Re: Case No. 20-1679-EL-BGN - In the Matter of the Application of Pleasant Prairie Solar Energy LLC for a Certificate of Environmental Compatibility and Public Need to Construct a Solar-Powered Electric Generation Facility in Franklin County, Ohio.

Response to First Data Request from Staff of the Ohio Power Siting Board

PLEASANT PRAIRIE SOLAR ENERGY LLC 'S
RESPONSE TO THE FIRST DATA REQUEST
FROM THE STAFF OF THE OHIO POWER SITING BOARD

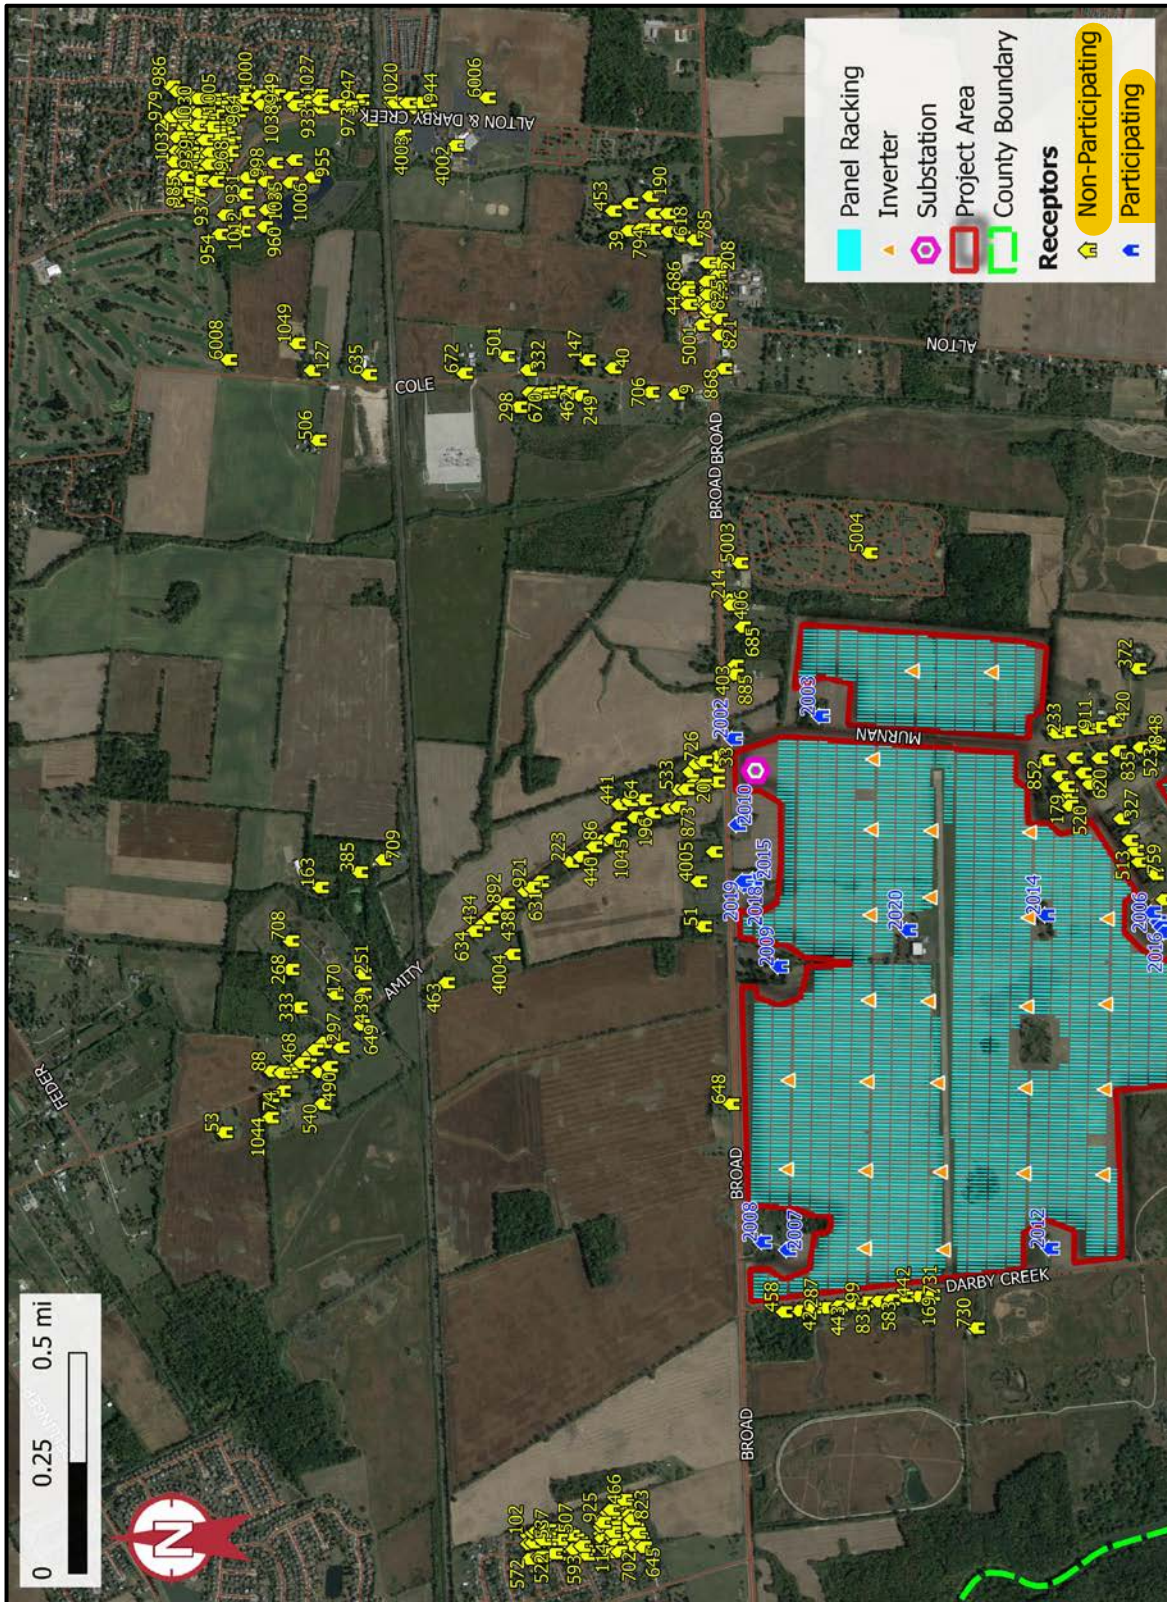
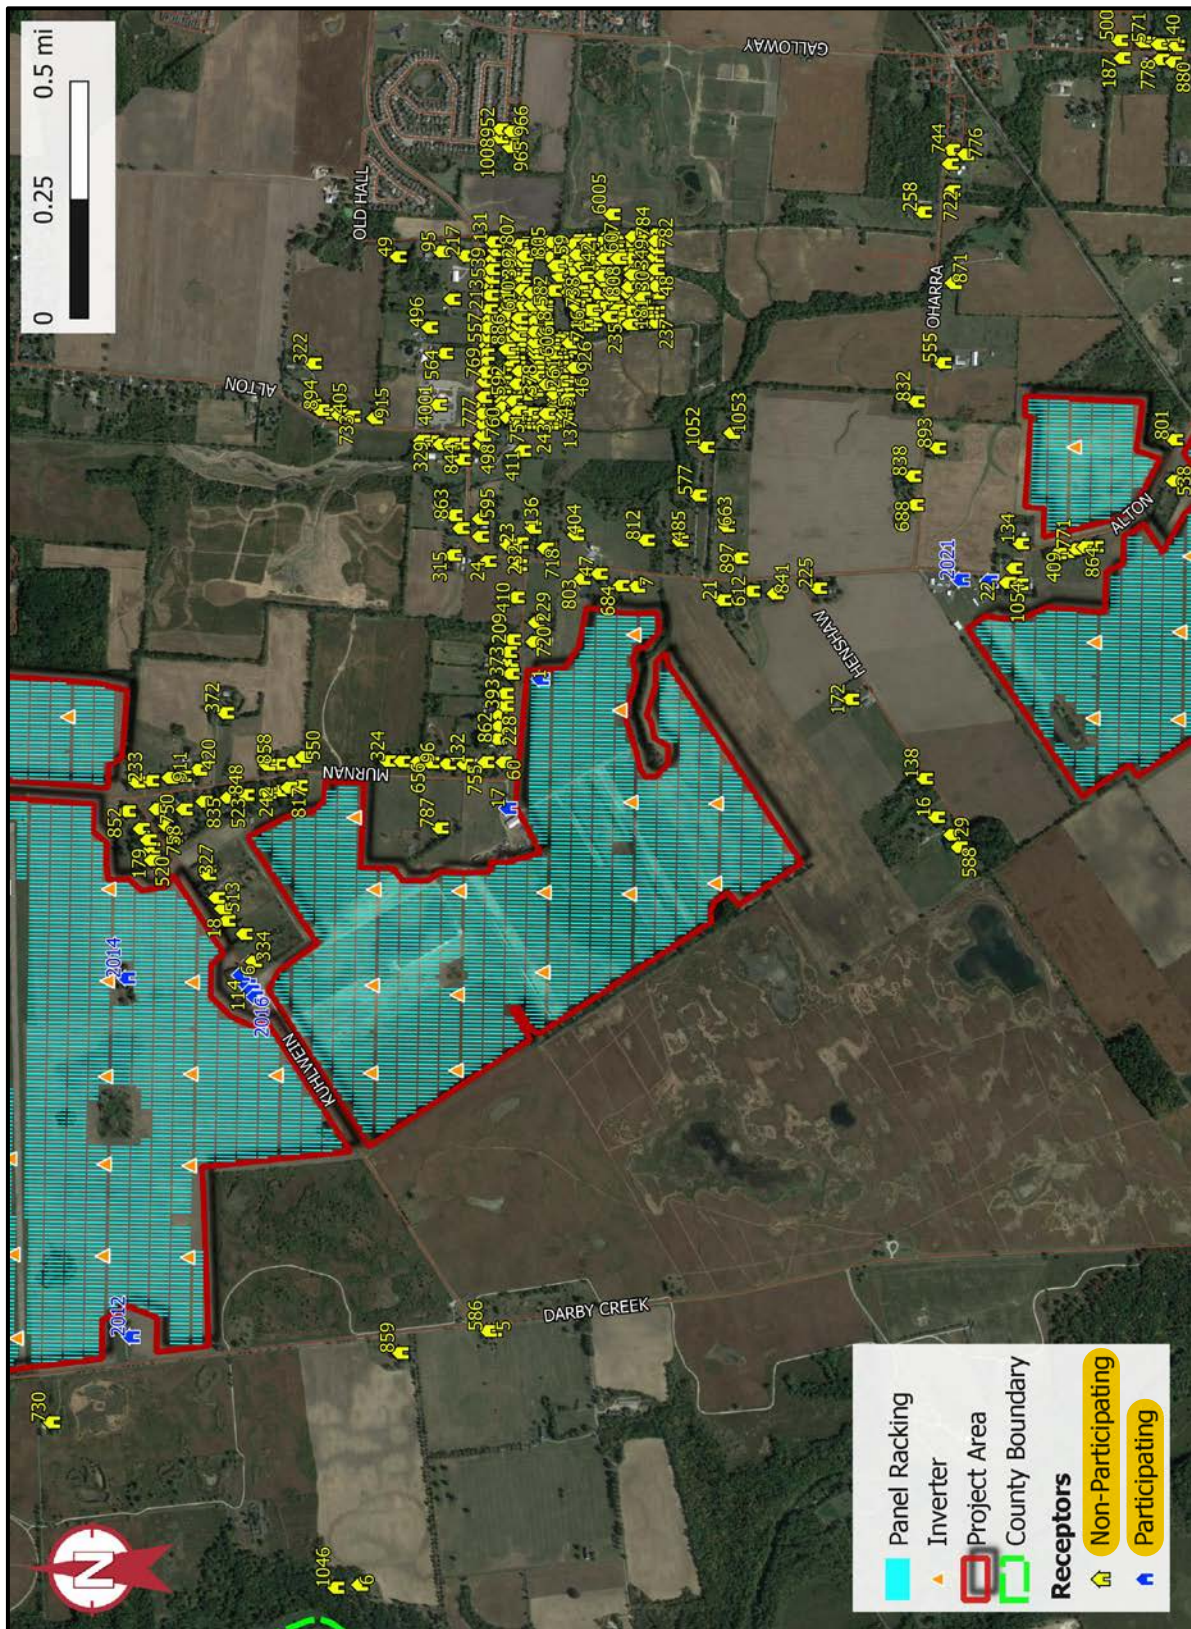
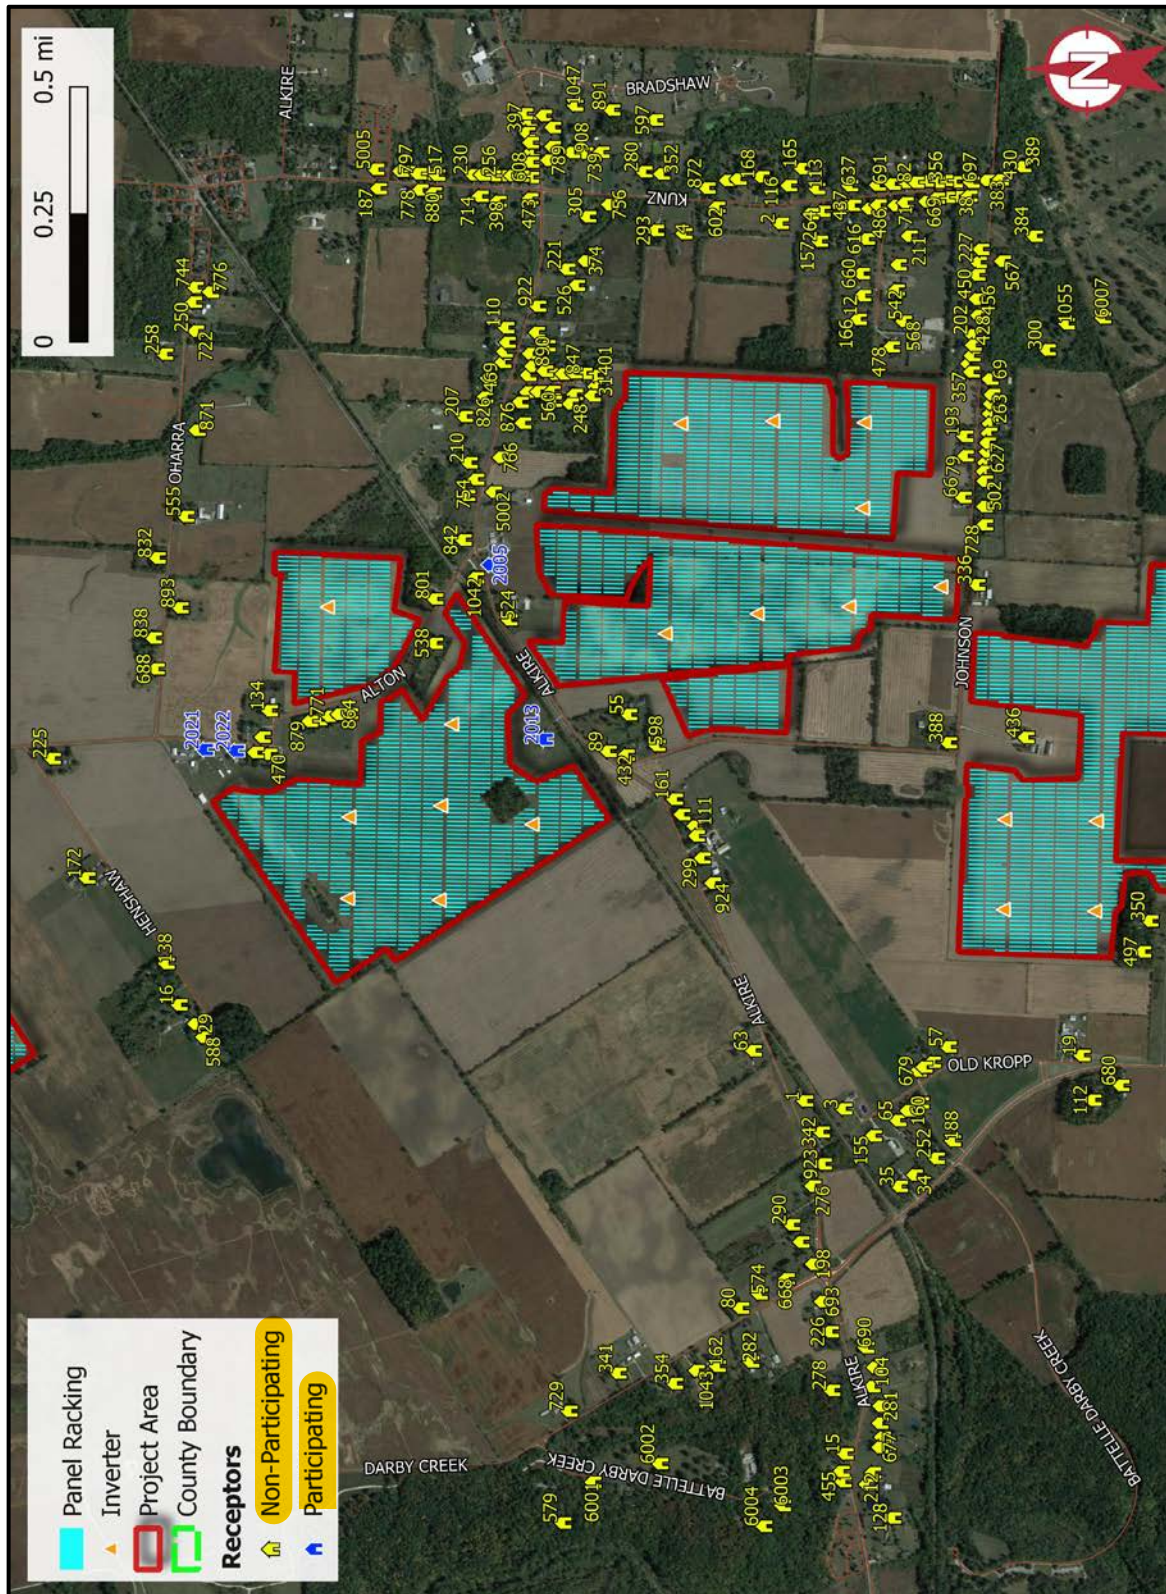
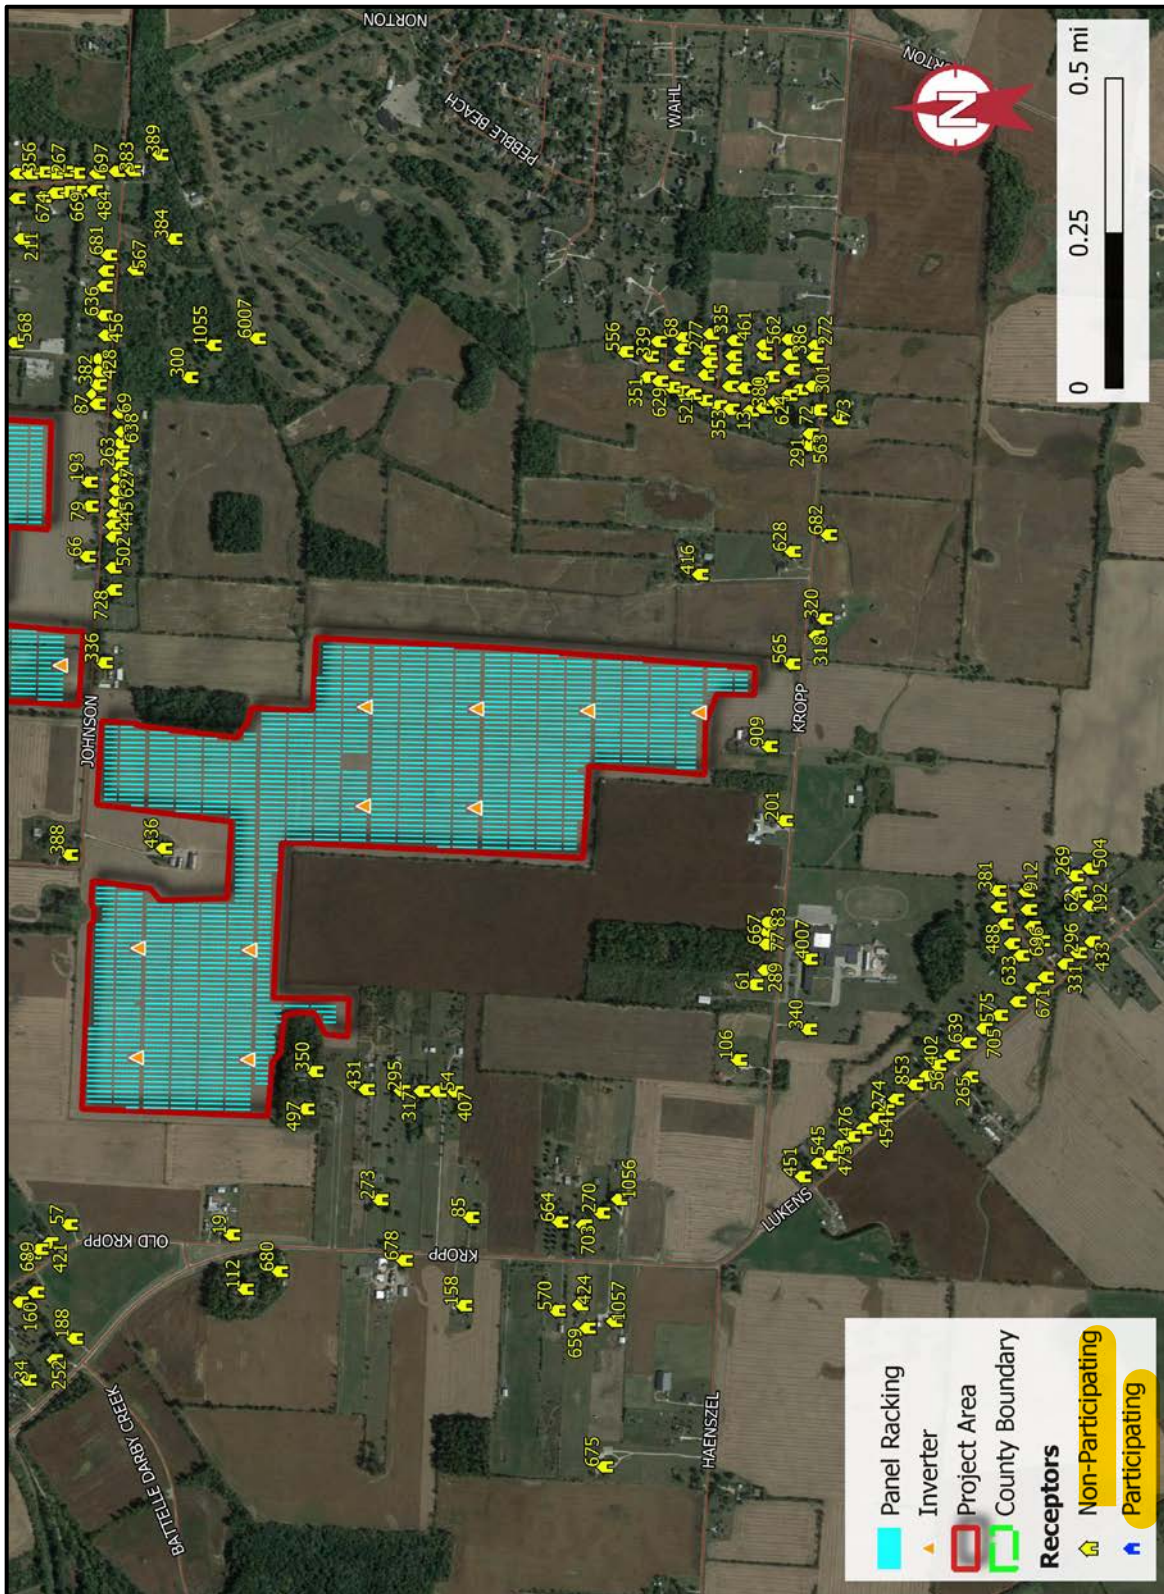
6. **Please update Figures 5-1, 5-2, 5-3, 5-4, 7-1, 7-2, 7-3, and 7-4 of the noise report with noise sensitive receptors differentiated between participating and non- participating receptors.**

Response: Please see Attachment 2 to this response, which is the updated and revised Application Exhibit N, the Sound Analysis conducted by Hankard Environmental, Inc., dated March 12, 2021 ("Sound Analysis"). Attachment 2 supersedes and replaces Application Exhibit N that was filed with the Application on February 19, 2021. The attached revised noise report differentiates the participating and non-participating information. For ease of review, in the attached update, the Applicant highlighted the revisions that were made to the Exhibit N that was filed with the Application on February 19, 2021.
